Access Compliance Report Public Rights-of-Way (Curb Ramps)

Main Street: HILLROSE_DR Cross Street: SILVER_FOX_RD Location: SE

ADA ID: RPRK211206172025 Ramp Type: Type 1 - Perpendicular Diagonal Initial Pass/Fail: Fail Overall Compliance: No Severity Score: 16

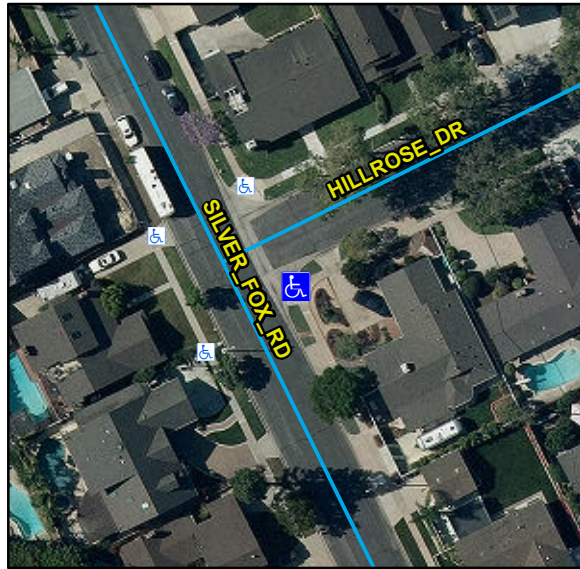
R204.3, R304.2.2, R304.5.3, STD 1115

Remove & Replace Curb Ramp With Two New Directional Ramps or Equivalent.
